# UNITED STATES PATENT AND TRADEMARK OFFICE

APPLICATION NO.	FILING DATE	FIRST NAMED INVENTOR	ATTORNEY DOCKET NO.	CONFIRMATION NO.
10/645,055	08/21/2003	Douglas A. Devens JR.	1001.2346101	6549

### Office Action Summary

### **DETAILED ACTION**

*Fig. 2b*

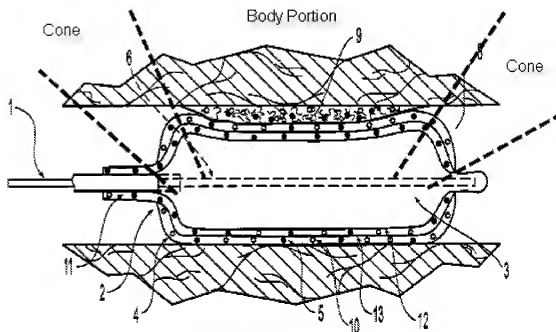
Regarding claims 1-3, 8, 10, 12, and 14, Ding et al disclose a medical device comprising a balloon (3) comprising a first portion having a first length (2), and a second portion disposed on the first portion having a second length (4), wherein the second portion defines an outer surface of the balloon; wherein the first portion varies in thickness along the first length and the second portion varies in thickness along the second length (Figs. 2a, 2b; see right hand side), wherein the balloon has a body

portion and a cone portion and wherein the first portion has a great thickness at the body portion than at the cone portion (Fig. 2b; the body portion of the first portion is thicker than the tapered portion of the cone; see Fig. 2b reproduced below for clarification).

Regarding claim 44, Ding et al also disclose that the balloon includes a tapered portion (see "cone" in the labeled Fig. 2b reproduced above), but do not explicitly teach or disclose that the body and tapered portions have different stiffness. Because the first and second layers taper sharply at the end of the tapered portion, the examiner believes this would impart additional flexibility to the tapered portion because, in general, when the thickness of a material is decreased, its flexibility is increased, and therefore its stiffness is decreased.
